**Lower El Mirage Wash
Phase 2 – Analysis and Recommendations
Design Concept Report**

FCD Contract No: 2008C014

Work Assignment No. 4

August 25, 2011

FIGURE 3
DESIGN CONCEPT SCHEMATIC
August 25, 2011

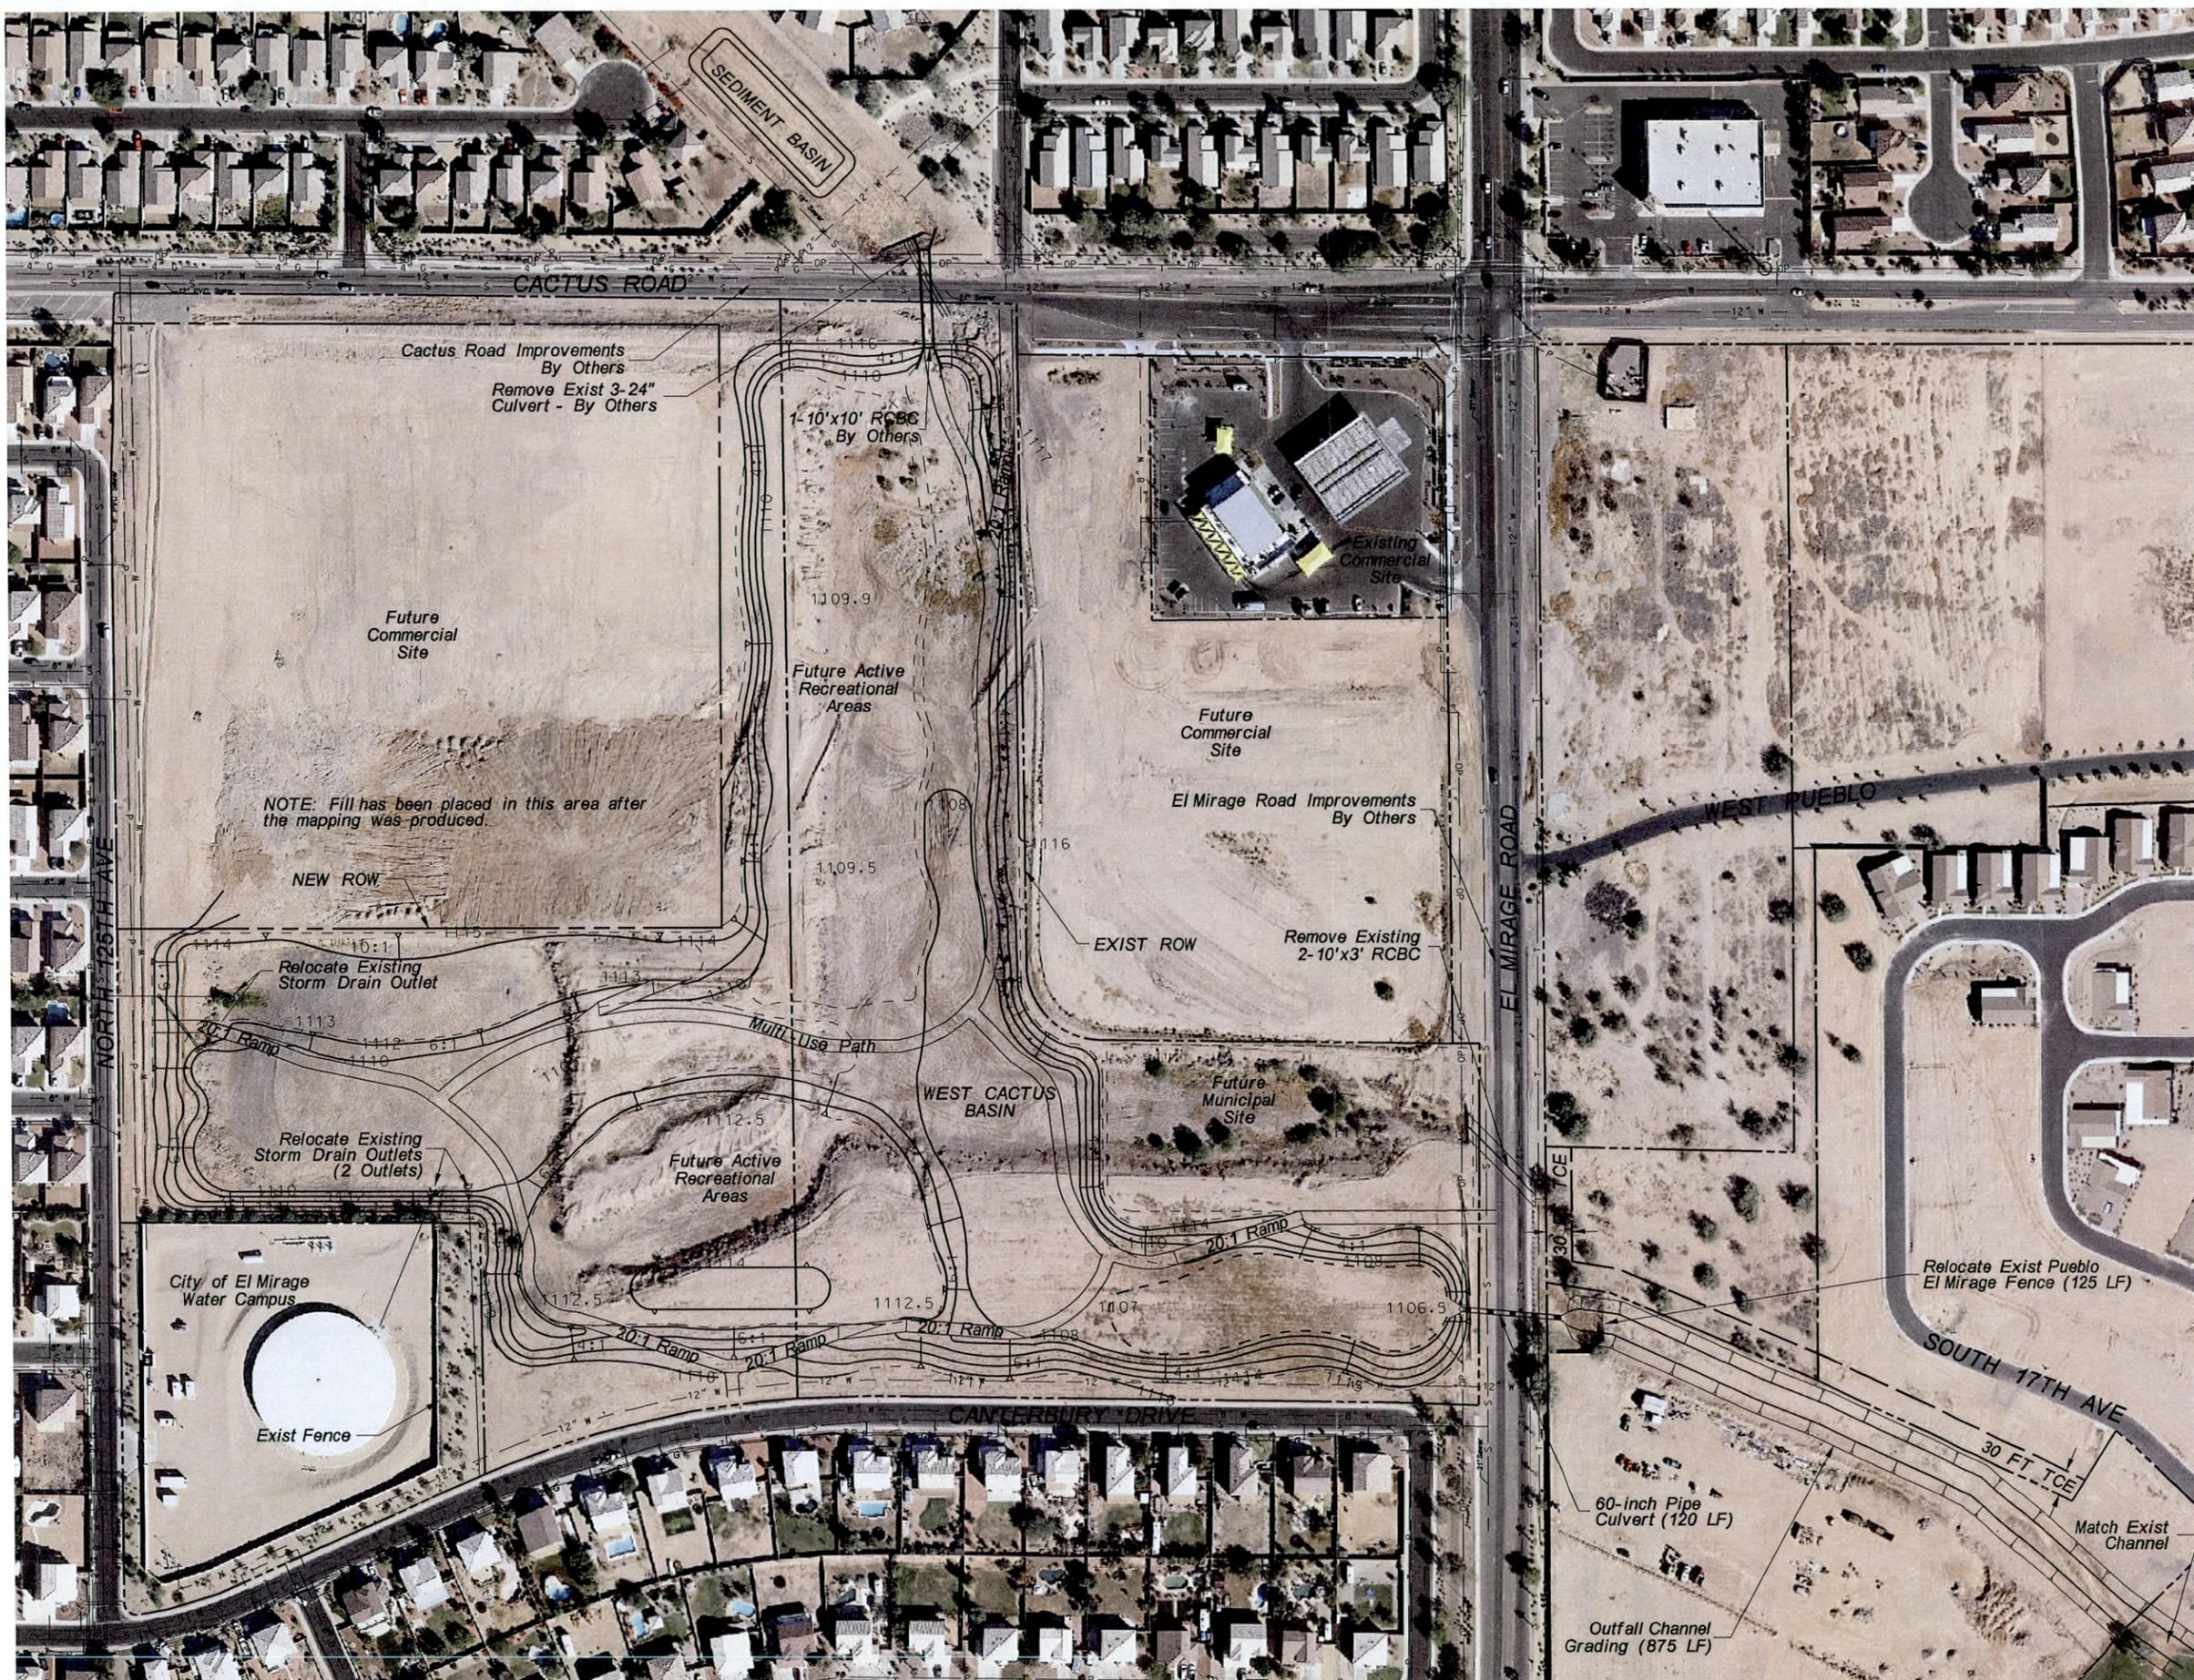
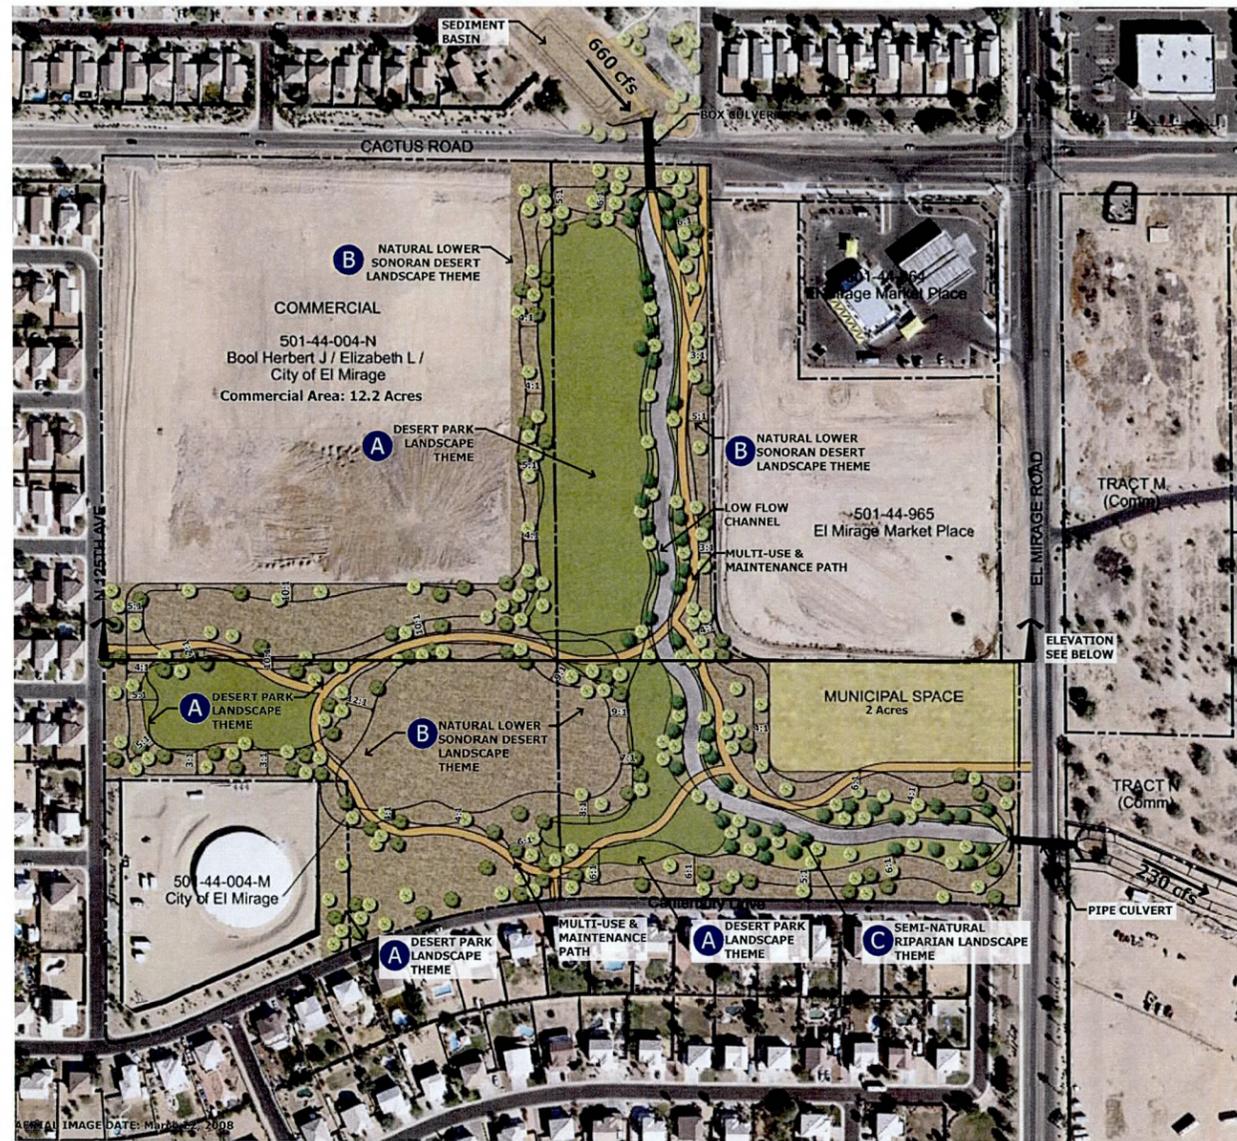
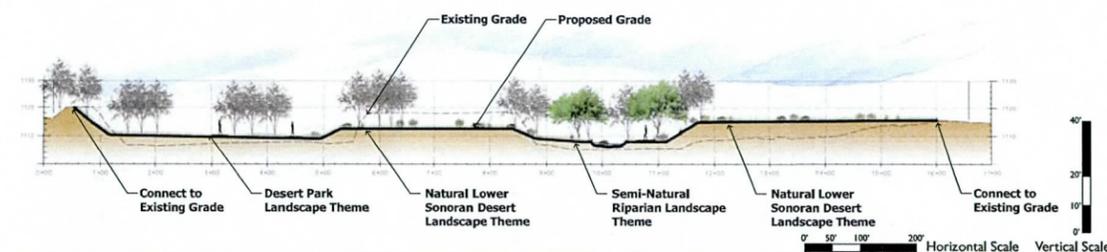
40	Flood Control District of Maricopa	VAS	Figure 3	A general 3:1 slope is preferred along the north side of the water tank.	J2	B	General 3:1 slopes are provided.	A	TAB
41	Flood Control District of Maricopa	VAS	Figure 3	Indicate downstream fence removal/modification at Tract N/ Pueblo property	J2	B	Per discussions with Valerie, AZTEC will be adding a new Figure 3 and the current Figure 3 will become Figure 4. The new Figure 3, Design Concept Schematic, will depict the downstream fence removal/modification. This figure is a graphic version of the Concept Plan.	A	TAB
42	Flood Control District of Maricopa	VAS	11.1	IGAs and Permits The IGA is not really something needed for Design Recommendations.	TAB	A	Will delete reference to IGAs.	A	TAB
43	Flood Control District of Maricopa	VAS	11.1	1st paragraph, last sentence. This sentence is out of place, it could be in its own paragraph expanding on the temporary easement.	TAB	A	Agree. This has been rewritten and included as a bullet item in Section 11.2.	A	TAB
